Re: Appalachian Power Company
Smith Mountain Project No. 2210
License Article 403
2021 Five-Year Sedimentation Monitoring Report
Request for Extension of Time

2021 Five-Year Sedimentation Survey Report

APPALACHIAN POWER COMPANY
SMITH MOUNTAIN PUMPED STORAGE PROJECT, NO. 2210
ARTICLE 403 – SEDIMENTATION MONITORING PLAN

SHEET 19 OF 24 SHEETS

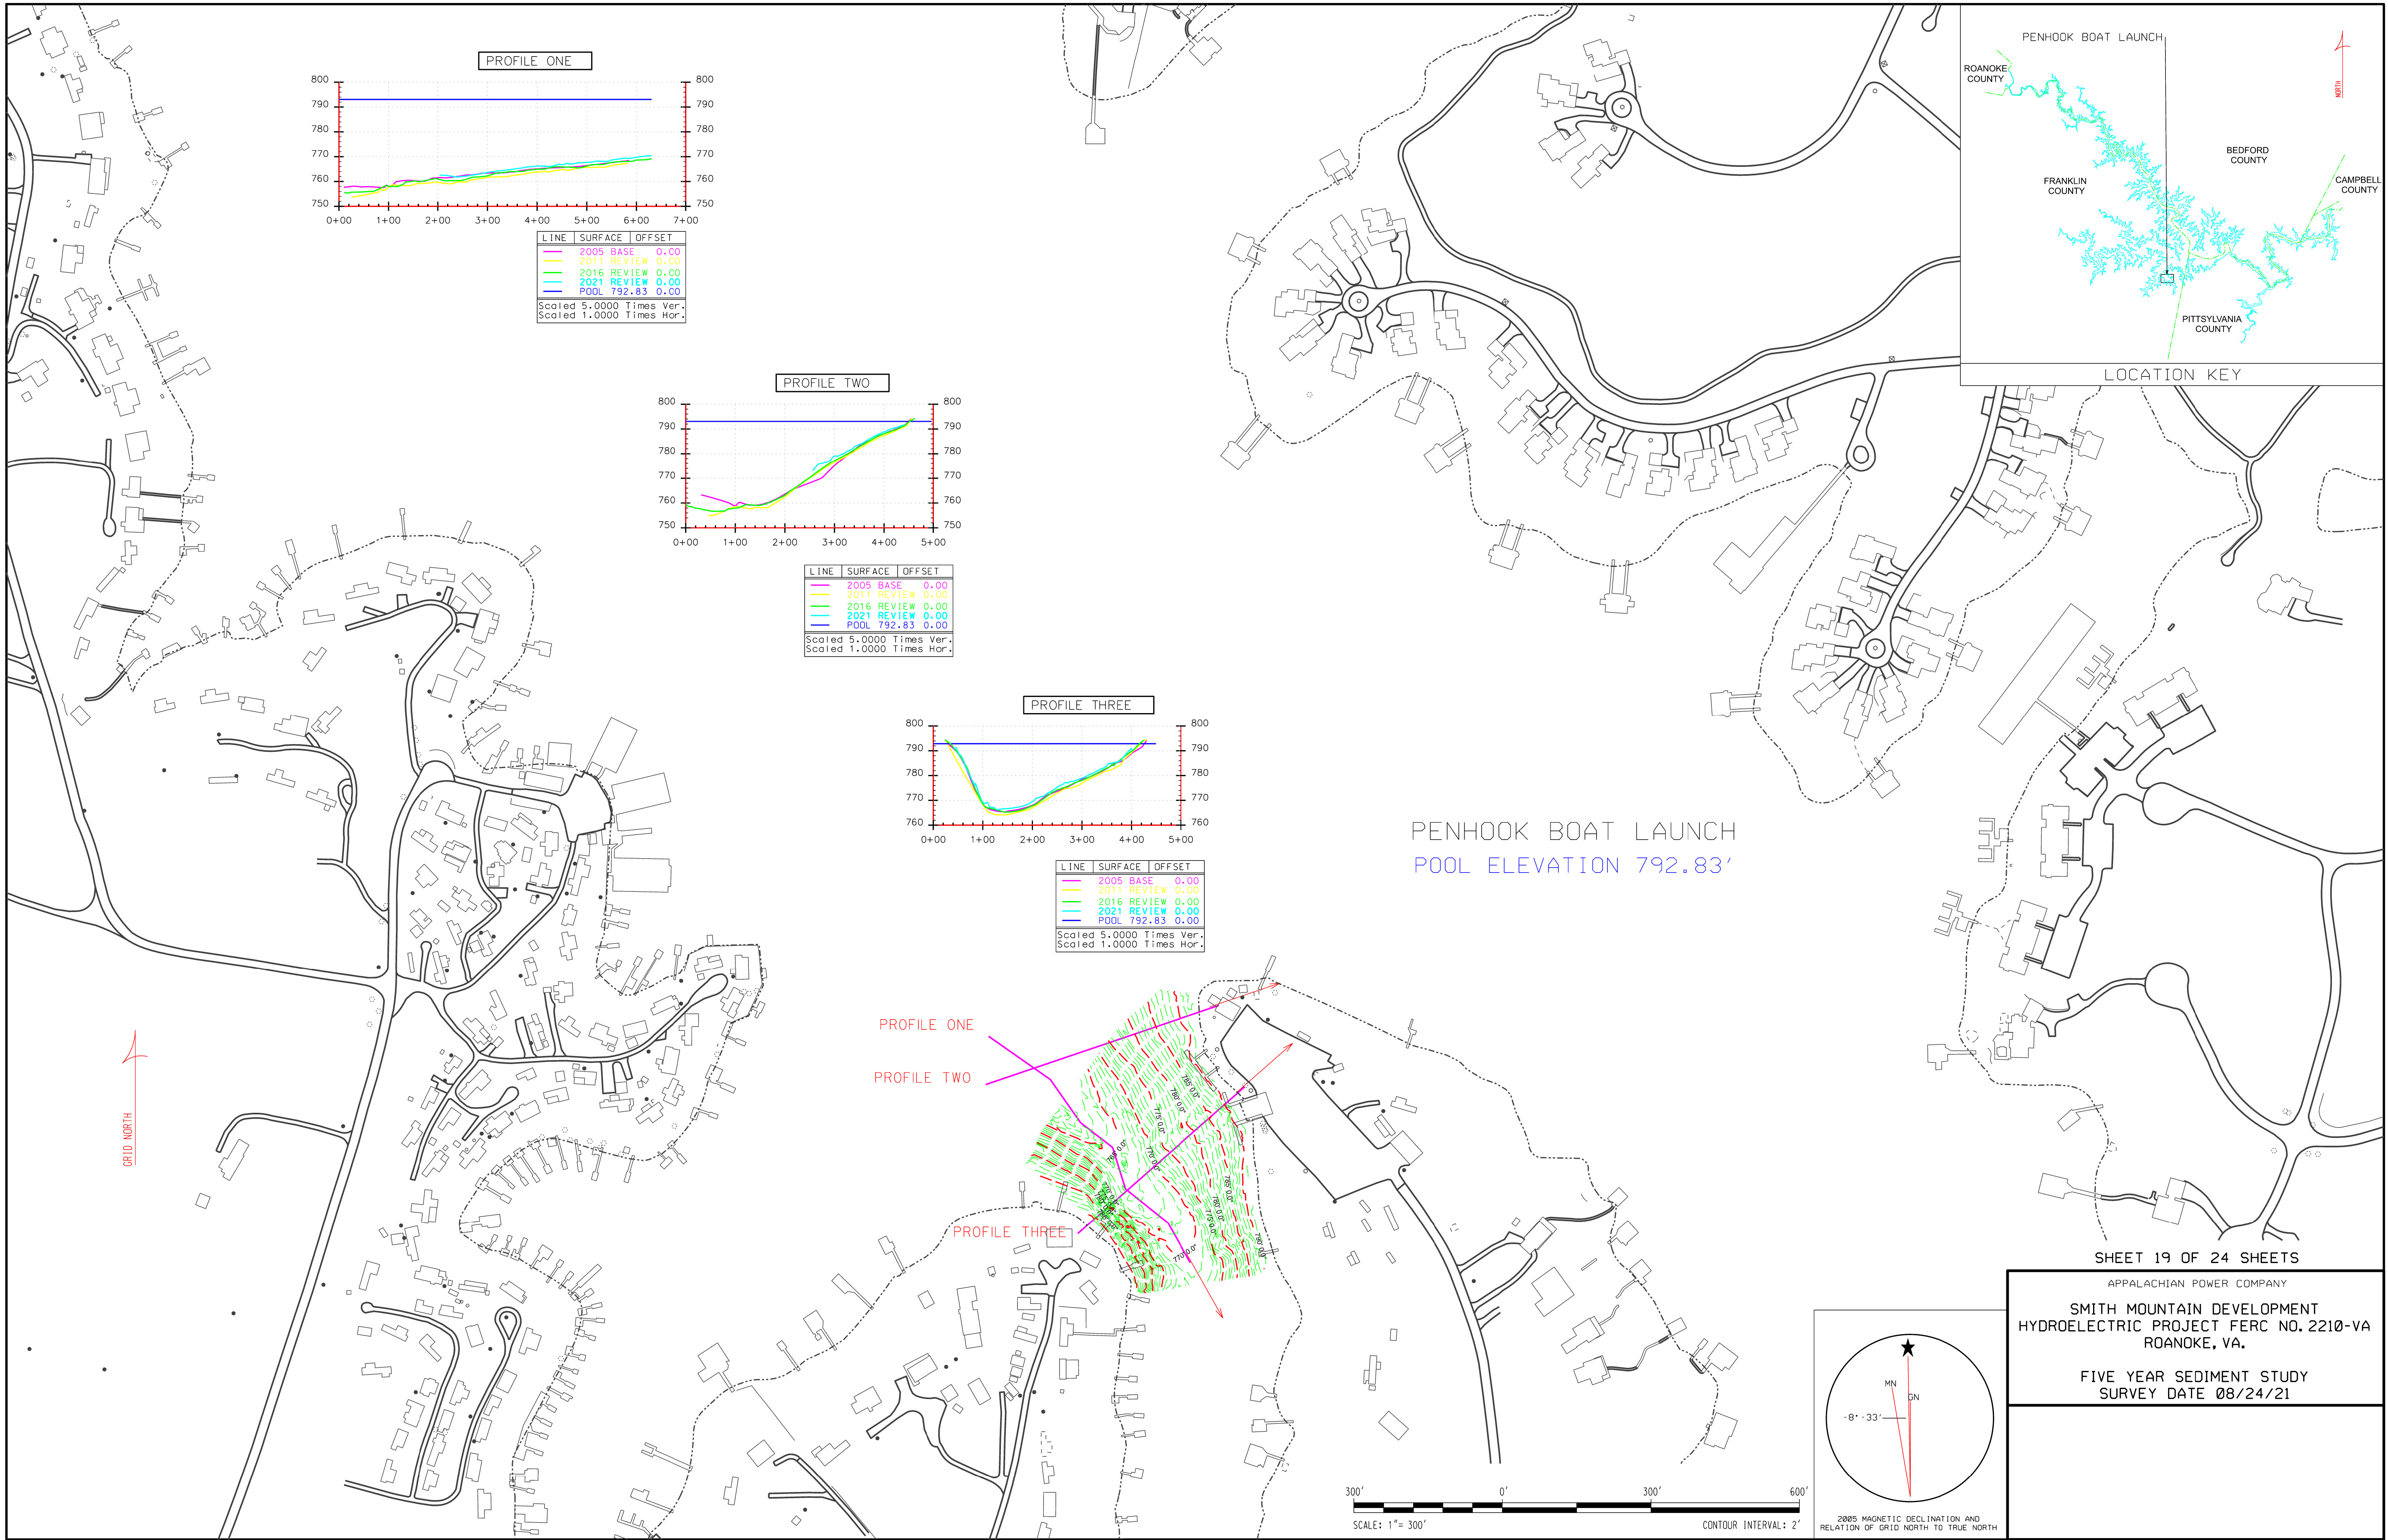
Thank you for the prompt turn-around of the Sedimentation Survey Report. One note of a change to be made in the summary for Penhook Boat Launch, the Hardy Ford Boat Launch is still referenced.

Note that there was one edit missed in the revised report. On page 4, under *Penhook Boat Launch*, "Hardy Ford" should be replaced with "Penhook". I have marked that edit for the final report.
